## 9.0 Auxiliary Systems

### 9.1 Fuel Storage and Handling

The information in this section of the reference ABWR DCD, including all subsections, tables and figures, as modified by the STP Nuclear Operating Company Application to Amend the Design Certification rule for the U.S. Advanced Boiling Water Reactor (ABWR), "ABWR STP Aircraft Impact Assessment (AIA) Amendment Revision 3," dated September 23, 2010, is incorporated by reference with the following departures and supplements.

STD DEP 9.1-1, Update of Fuel Storage and Handling Equipment (Tables 9.1-3, 9.1-4, 9.1-5, 9.1-6, 9.1-7, 9.1-8, 9.1-11, Figures 9.1-4, 9.1-5, 9.1-7, 9.1-8, 9.1-11, 9.1-12, and 9.1-14)

Figure 9.1-3 Fuel Preparation Machine Shown Installed in Facsimile Fuel Pool

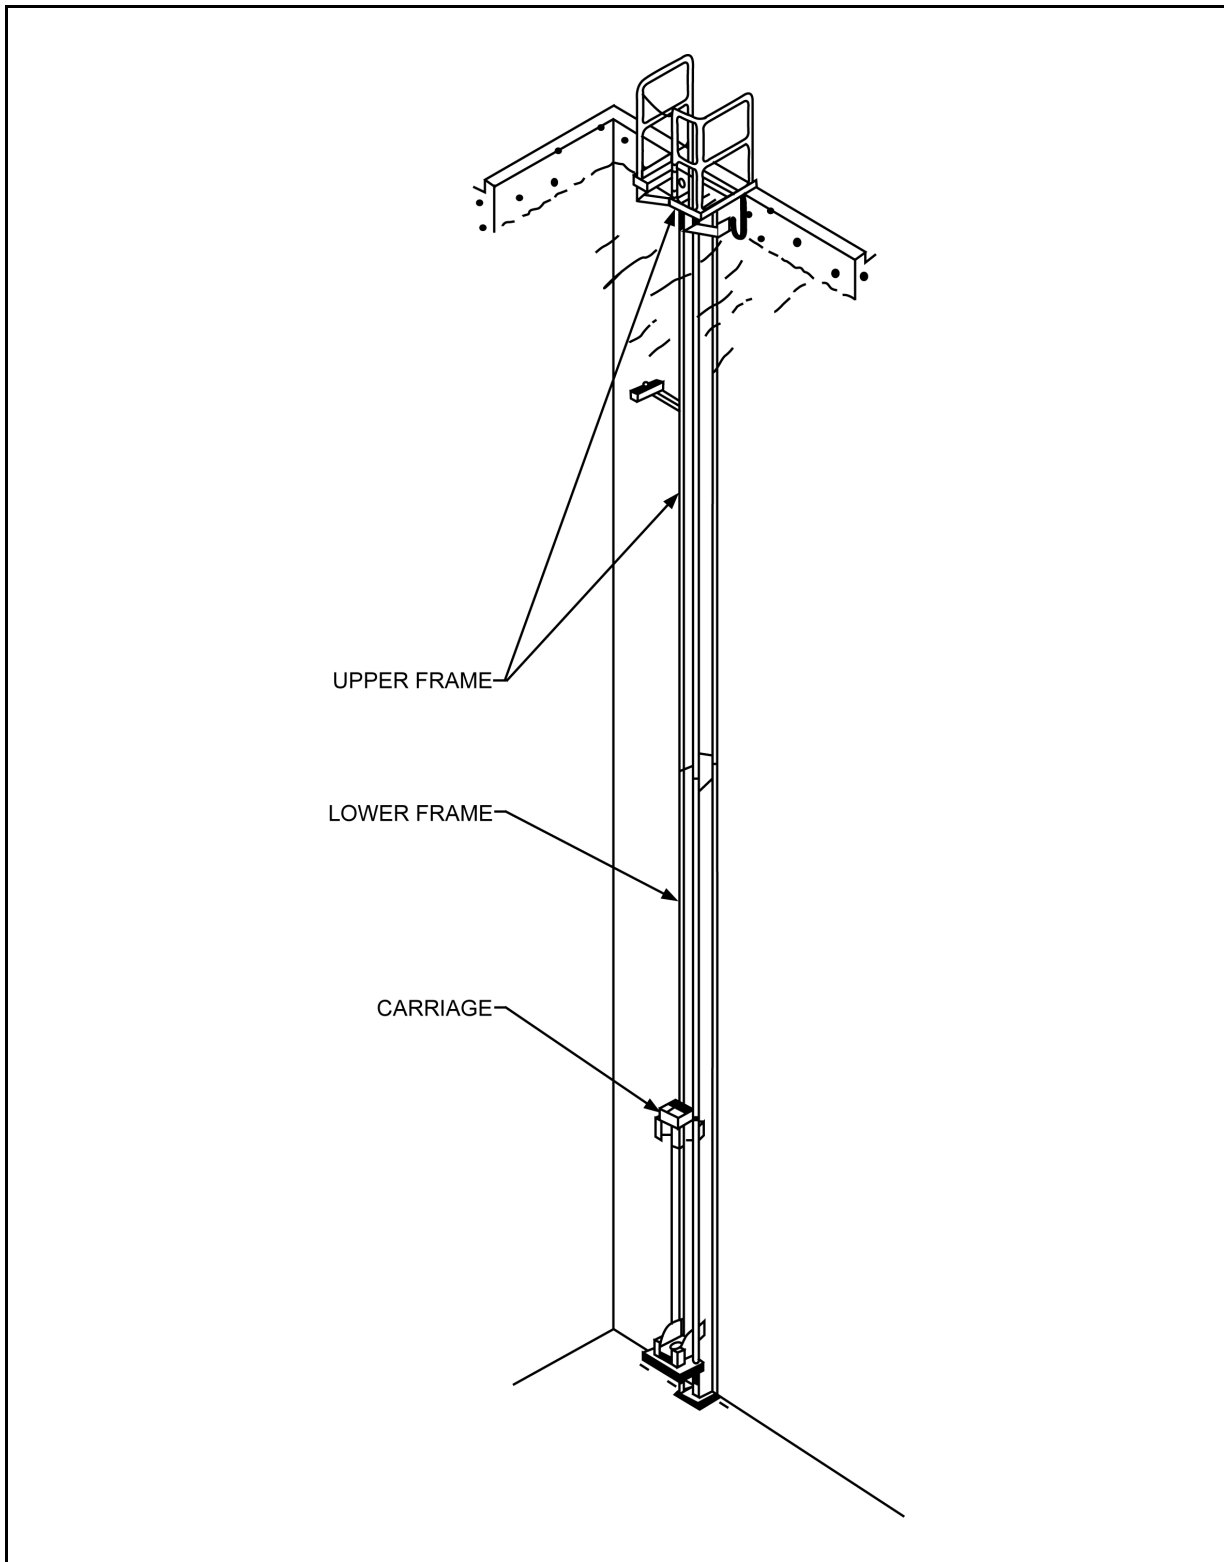
*Two fuel preparation machines (Figure 9.1-3) are mounted on the wall of the spent-fuel pool and are used for ~~stripping reusable channels from the spent fuel and for~~*

channeling and rechanneling of the new and spent fuel assemblies. The machines are also used with the fuel inspection fixture fixtures to provide an underwater inspection capability. The fuel prep machines also serve as a staging location to allow movement of new or spent fuel assemblies into the spent fuel pool storage racks.

Figure 9.1-4 New-Fuel Inspection Stand

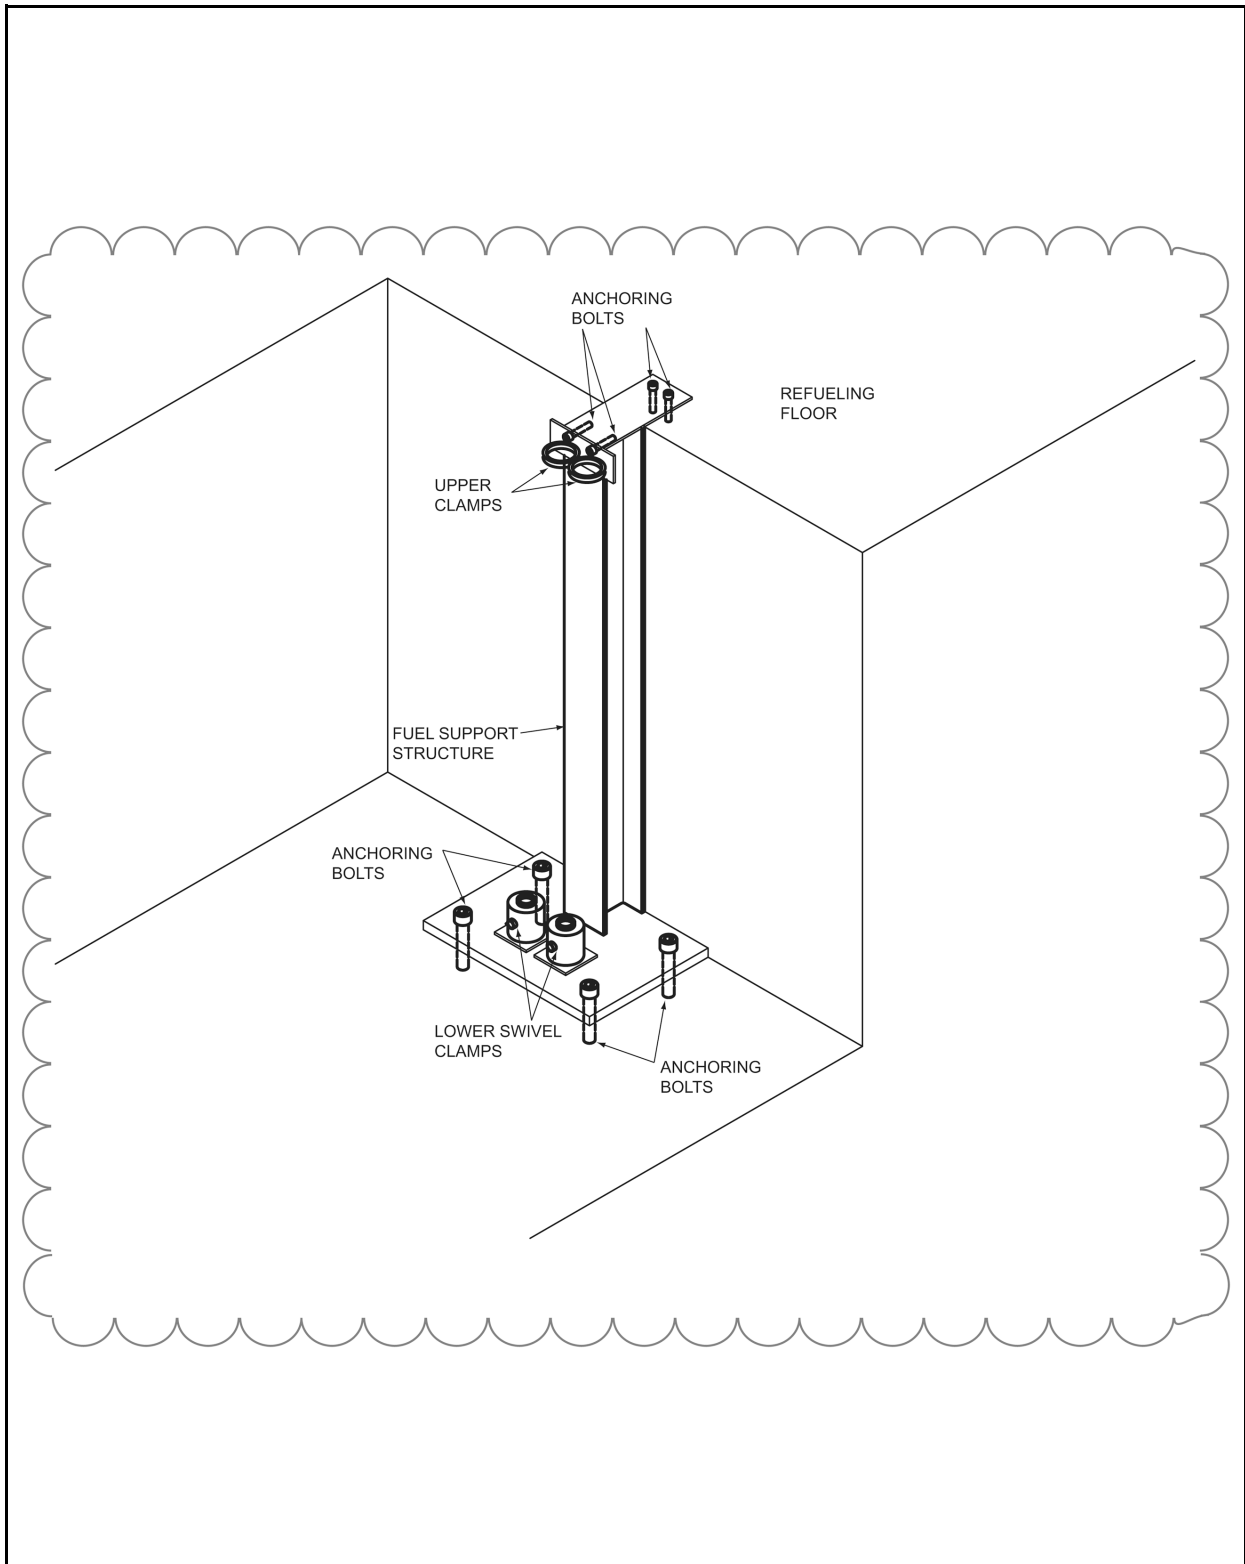
The new-fuel inspection stand (Figure 9.1-4) serves as a support for the new-fuel bundles undergoing receiving inspection ~~and provides a working platform for technicians engaged in performing the inspection.~~

Figure 9.1-5 Channel Bolt Wrench

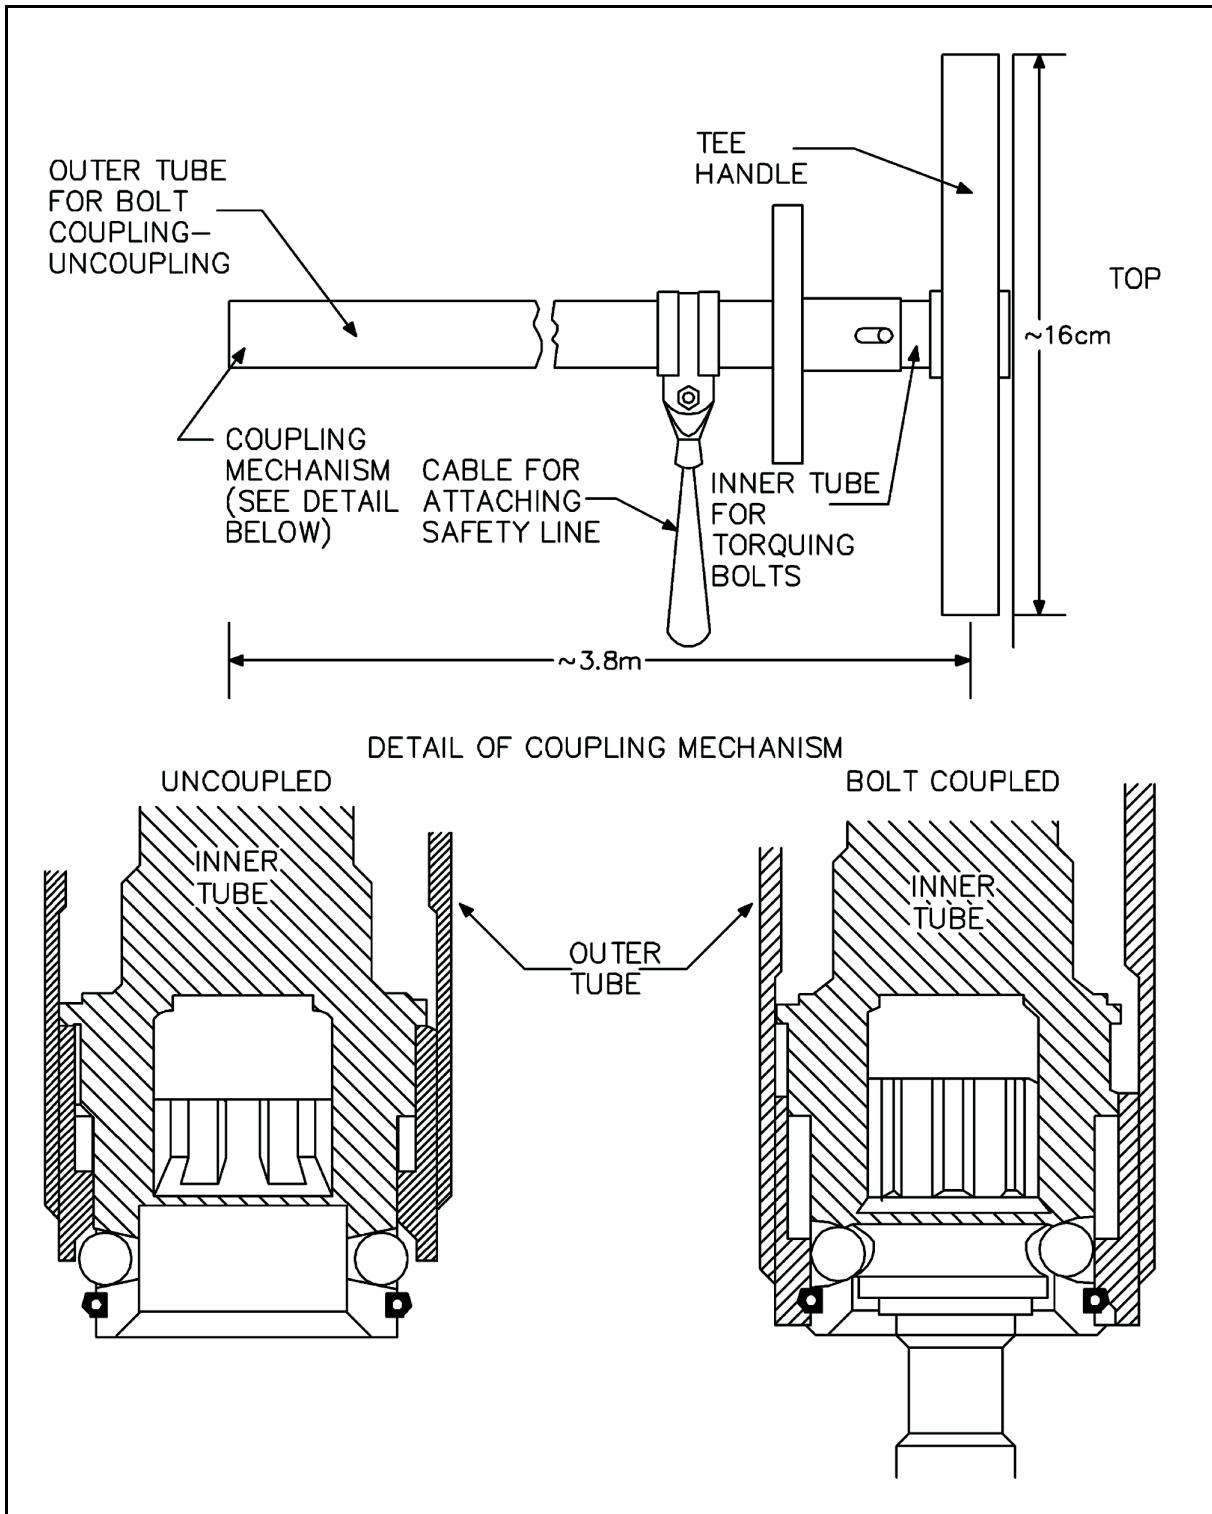
The channel bolt wrench (Figure 9.1-5) is a manually operated device approximately ~~3.763.8m~~ 3.8m in overall length. The wrench is used for removing and installing the channel fastener assembly while the fuel assembly is held in the fuel preparation machine. The channel bolt wrench has a socket which mates and captures the channel fastener capscrew.

Figure 9.1-8 General-Purpose Grapple

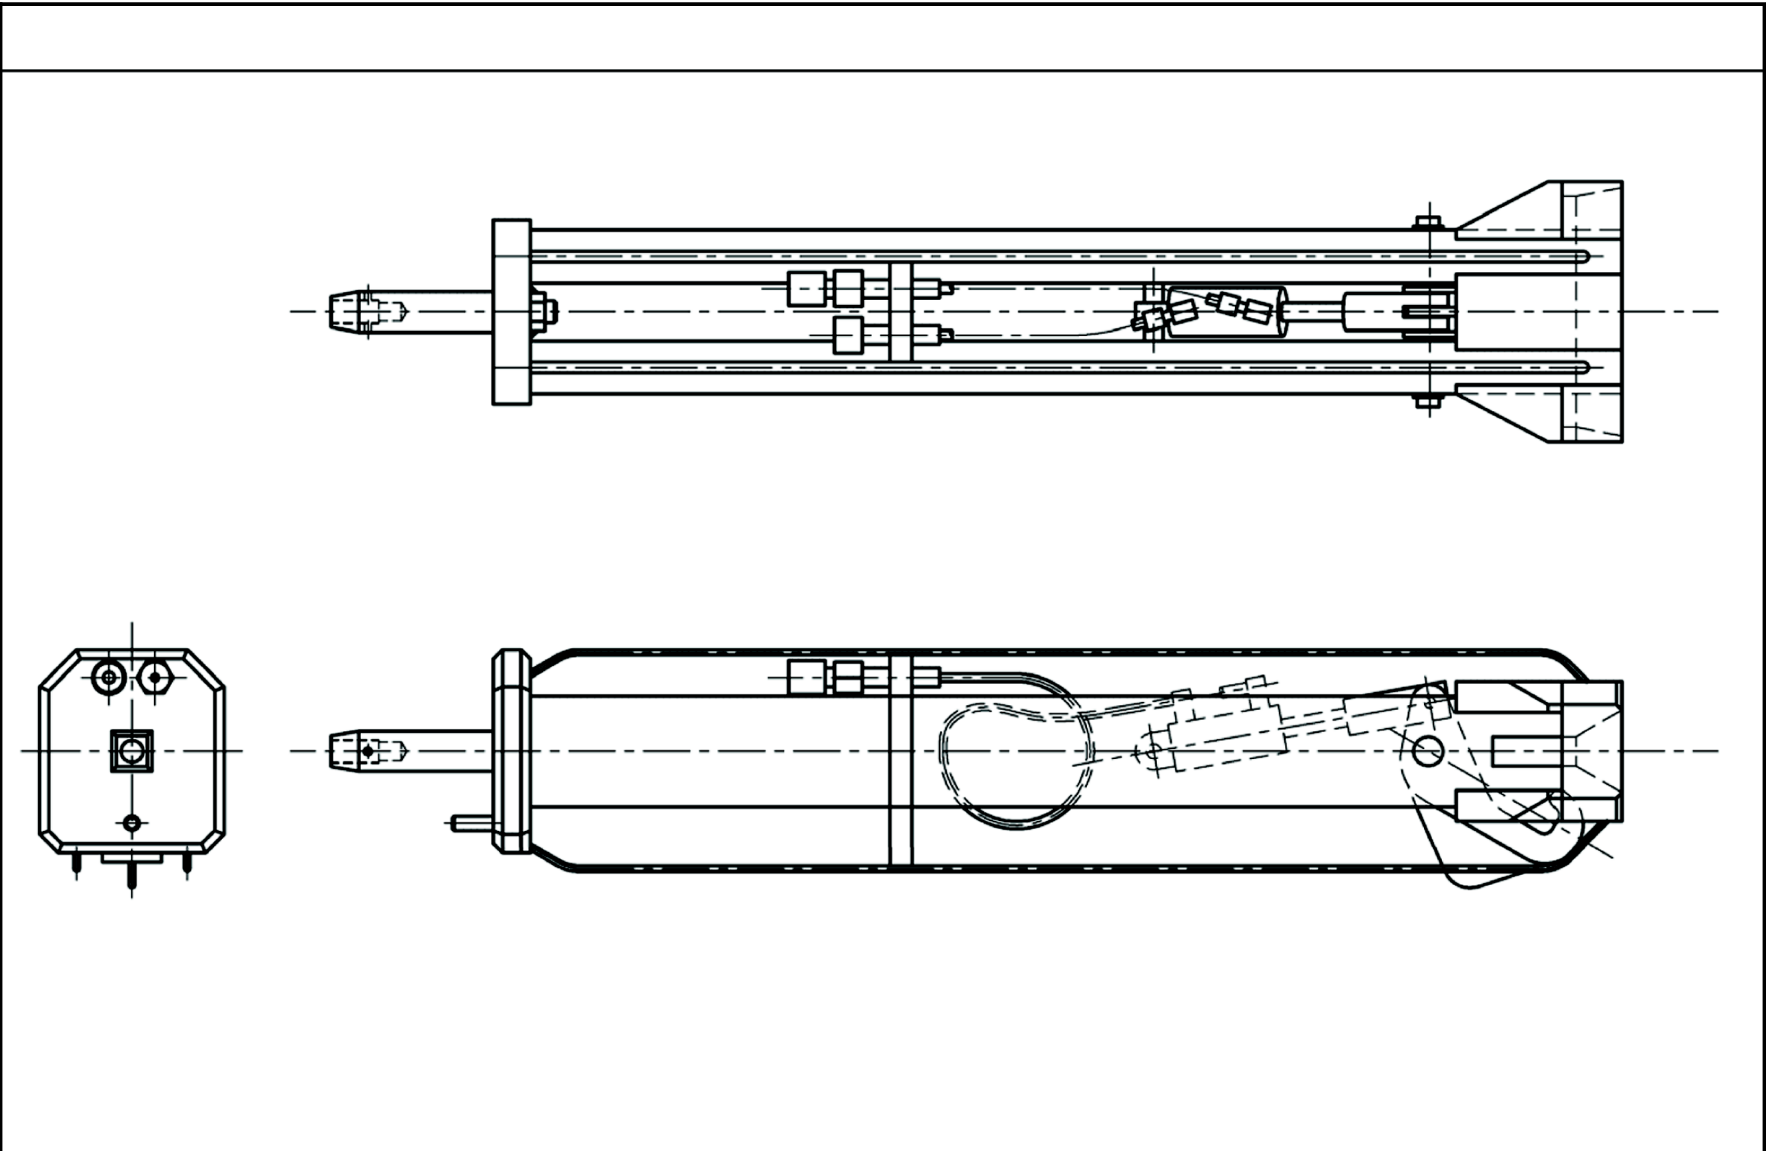
The general-purpose grapple (Figure 9.1-8) is a handling tool used generally with the fuel. The grapple can be attached to ~~the jib crane to handle fuel during channeling, or~~ the refueling machine auxiliary hoist.

Figure 9.1-14 Simplified Section of New-Fuel Handling Facilities

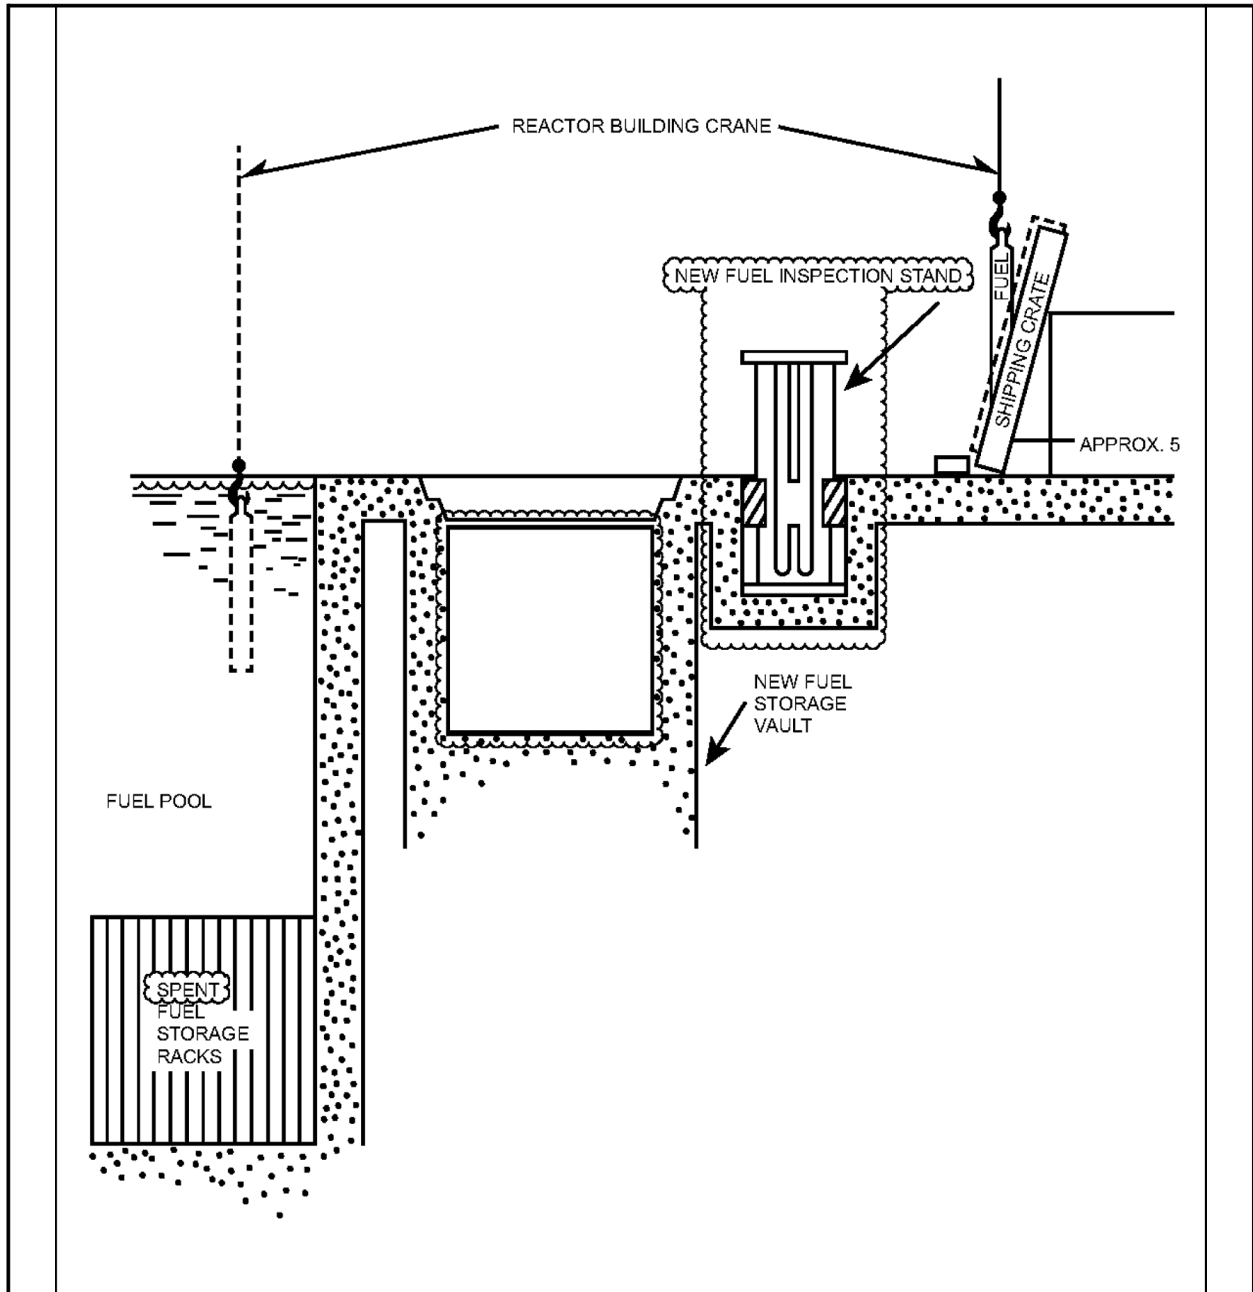
STP DEP T1 2.5-1, Elimination of New Fuel Storage Racks in New Fuel Vault (Table 9.1-8, Figure 9.1-14)
